### **Reason for ERB Review:**

### **Project Description with respect to Impacts to Biological Resources:**

EXHIBIT 5: HABITAT CATEGORY DELINEATION  
RICKLEY RESIDENCE | LOS ANGELES CO., CA

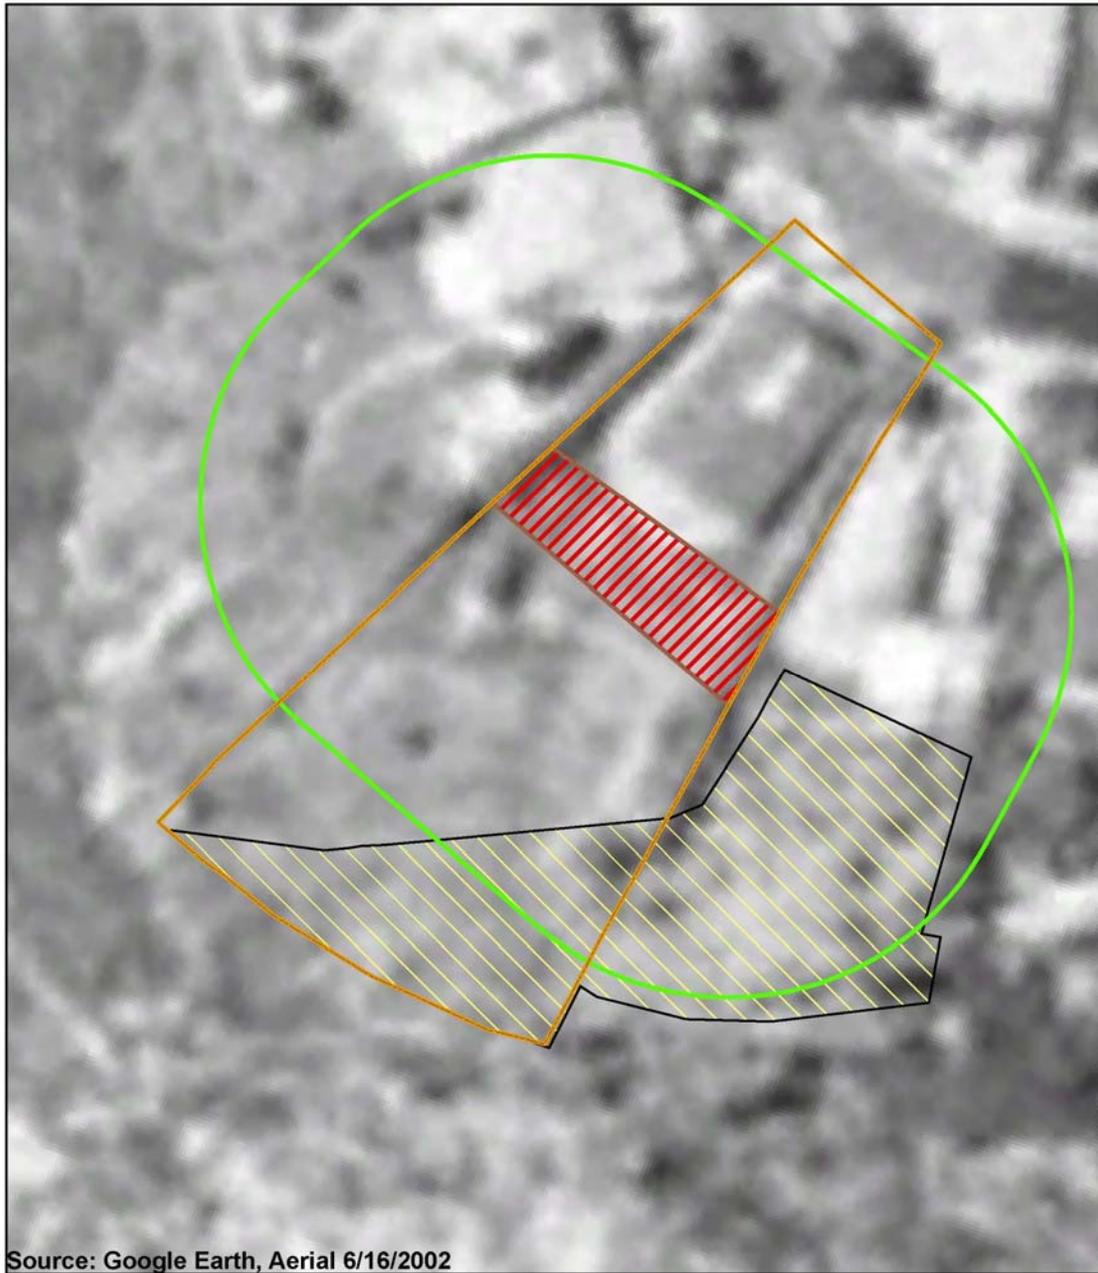
Current aerial photographs (Google Earth and Los Angeles County GIS) indicate that both the area within 100 feet of the Proposed Project location and all of the area shown in Exhibit 5 on both the Rickley and Yazdani parcels do not contain natural vegetation. While those same photographs show that natural vegetation in the form of California encelia scrub exists adjacent to the Property (but more than 100 ft. from the Proposed Project), no new impacts to biological resources are expected or proposed as part of the permitting of the Proposed Project.

confirmed in the Biological Resources Map found at Map 2 to the LUP that was adopted in 2014. The NPS mapping was conducted based on aerial photographs. The LIP allows, in the event of mapping inconsistencies, for a “prove-in/prove-out” approach to modifying Habitat Categories based on site conditions. Specifically, County Code section 22.44.1830.A, provides that as part of the coastal development permit process and based on substantial evidence, a resource on any site may be classified or reclassified from one category to a higher or lower category and those changes reflected on the Biological Resources Map of the LUP found at Map 2. An evaluation of the H1 habitat mapped within 100 feet of the Proposed Project demonstrates that the H1 habitat is more appropriately considered H3 habitat. It is therefore recommended that the ERB consider, and recommend to the Hearing Officer, that such area (as shown in Exhibit 5) be re-designated as H3 habitat.

1. The Biological Resources Map be modified to show all the land shown in Exhibit 5 and designated as H-1 will be reclassified and shown as H-3;
2. The ERB find that the H-1 buffer of 100 feet is not violated by this proposed project;
3. The ERB find that the Proposed Project will not have an impact on mapped H1 habitat, and that the proposed development may proceed consistent with the policies of the LCP; and
4. That the minor Coastal Development permit be approved subject to conditions recommended by Staff.
